CALVERT CLIFFS NUCLEAR POWER PLANT UNIT NO. 1

Amendment No. 85
License No. DPR-53

Amendment No. 68
License No. DPR-69

SAFETY EVALUATION BY THE OFFICE OF NUCLEAR REACTOR REGULATION

Figure 6.2.2 Organization Chart (Two Unit Operation) - Calvert Cliffs Nuclear Power Plant Baltimore Gas and Electric Company

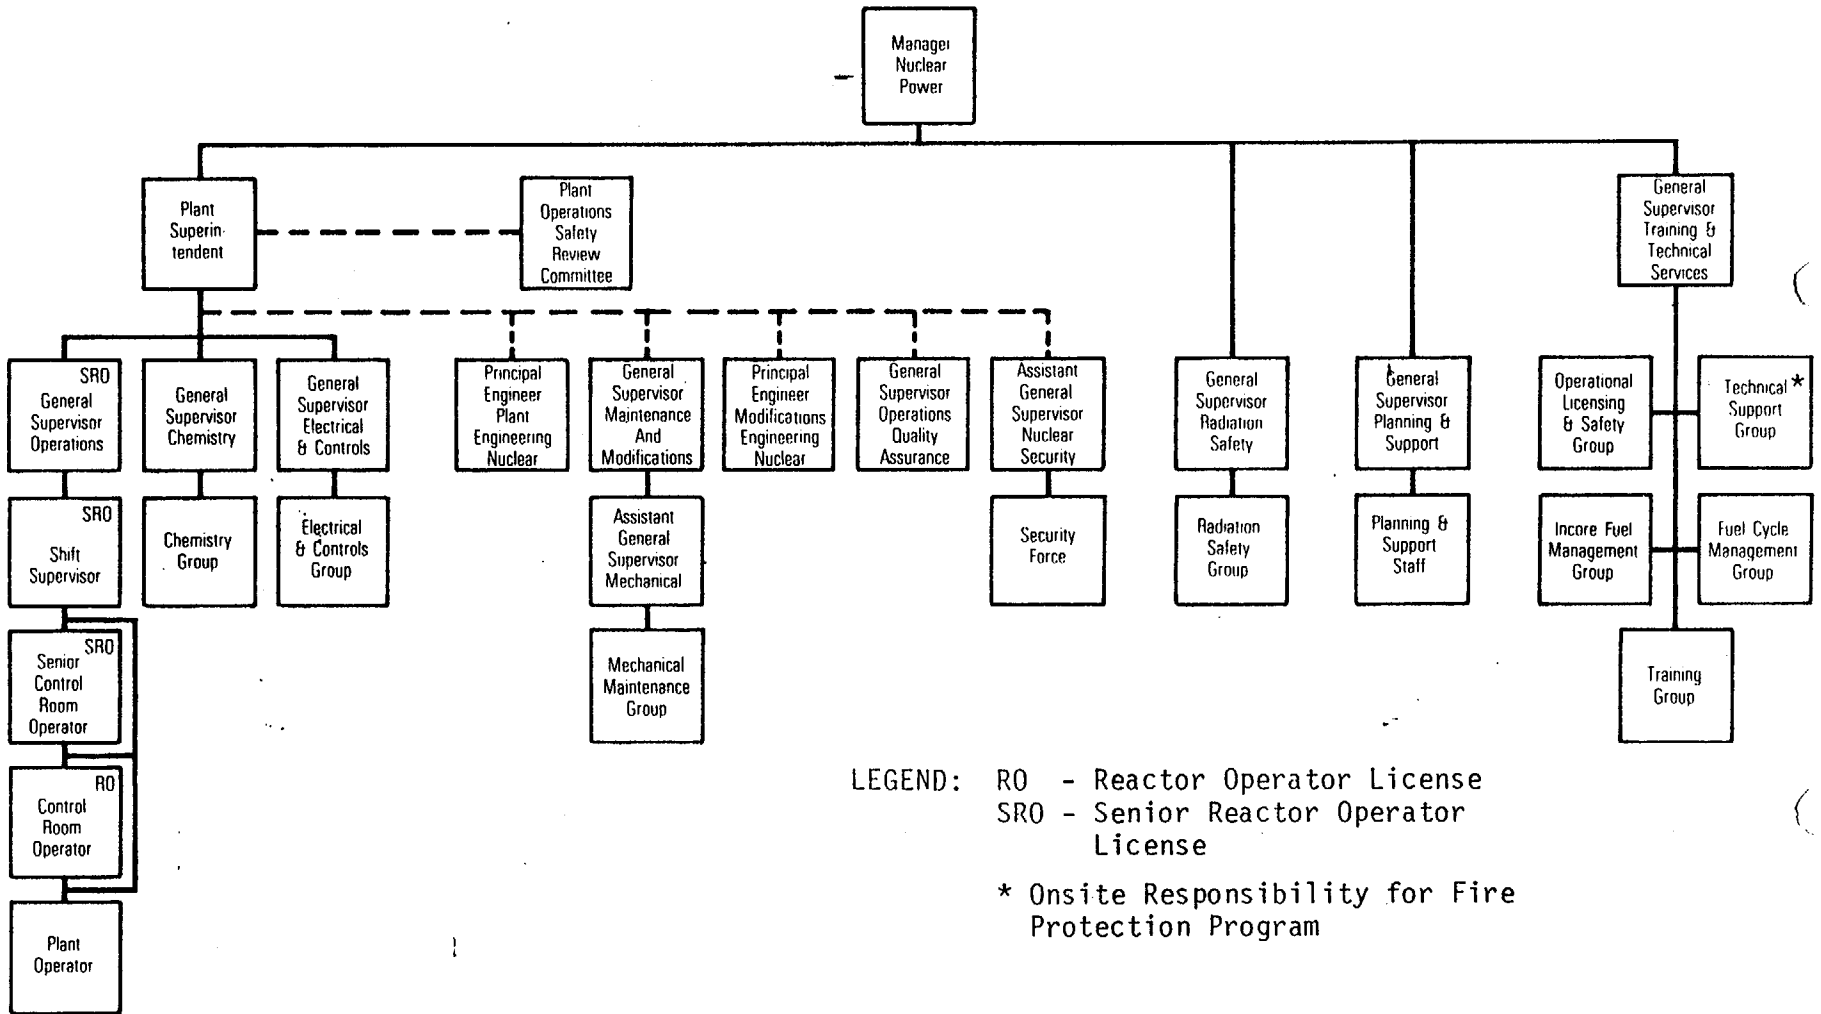
BG&E has proposed changes to Section 6.0 of the TS in two areas, namely Figure 6.2.2 Organization Chart - Calvert Cliffs Nuclear Power Plant, and the composition of the Plant Operations and Safety Review Committee (POSRC) membership as noted in Section 6.5.1.2. These TS changes are required to reflect changes in the on-site organization at Calvert Cliffs.

The position of Supervisor-Nuclear Fuel Management is to be eliminated at Calvert Cliffs. The Nuclear Fuel Management group will be divided into two parts, Incore Fuel Management and Fuel Cycle Management, both of which report to the General Supervisor-Training and Technical Services. A new position of General Supervisor-Planning and Support will be formed with a Planning and Support staff reporting to him, which will encompass the present responsibilities of the Supervisor-Administrative Services. The job title of General Foreman and Assistant General Foreman-Mechanical will be changed to General Supervisor-Maintenance and Modifications and Assistant General Supervisor-Mechanical, respectively. The job title of Supervisor-Calvert Cliffs Security will be changed to Assistant General Supervisor-Nuclear Security. Proposed TS Figure 6.2.2 reflects these organizational and title changes.

We have reviewed the proposed changes to the Calvert Cliffs on-site organization as reflected in TS Figure 6.2.2. We conclude that the changes will not degrade the technical or administrative functioning of this organization and are therefore acceptable. In addition, we find that the proposed change to TS 6.5.1.2 is acceptable in that the proposed change to the POSRC will not degrade the ability of the POSRC to advise the Plant Superintendent on all matters related to nuclear safety at Calvert Cliffs.
